MERCURY PERFORMANCE OUTBOARDS

No. 93-4

2.5 EFI Fuel Adjustment

Models: All MHP Mercury and Mariner 2.5 EFI/2.5 EFI Offshore Outboards

11350A27 ECU BOX

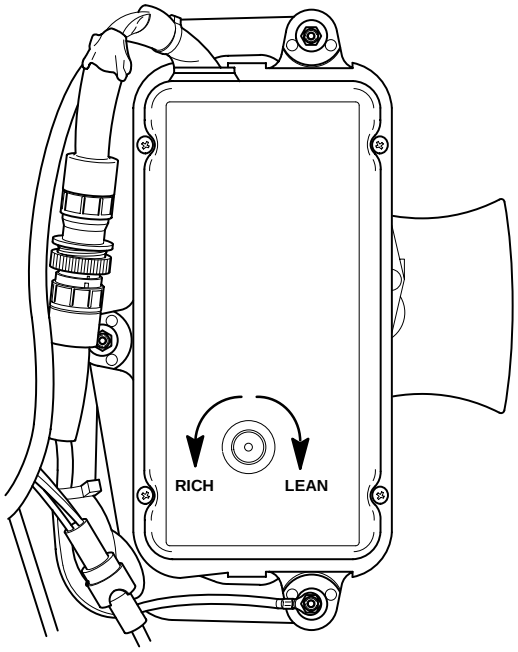
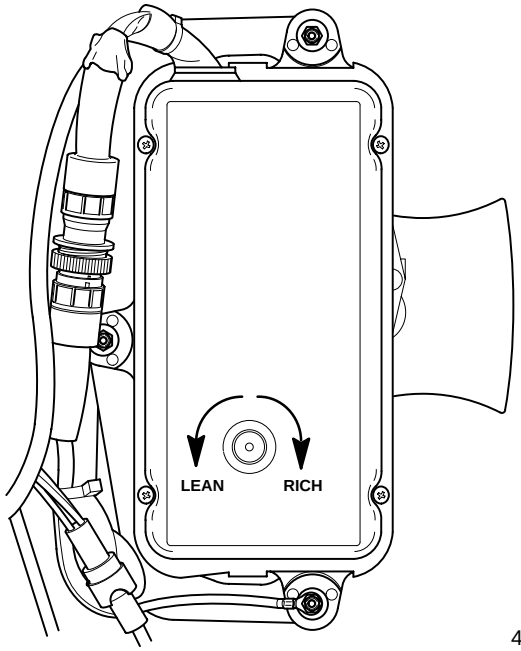
The ECU box (11350A27) used on all 2.5 EFI engines after serial number D181381 has a fuel adjustment potentiometer that affects fuel /air ratio opposite all previous plastic covered ECU boxes. See illustrations that follow for proper fuel adjustment.

1. Use EFI Tester Manual for tester set-up.
2. Normalize ECU box for your application.
3. Turn potentiometer adjusting screw. If the normalization number increases, the air/fuel ratio is richer; if the number decreases, the ratio is leaner.
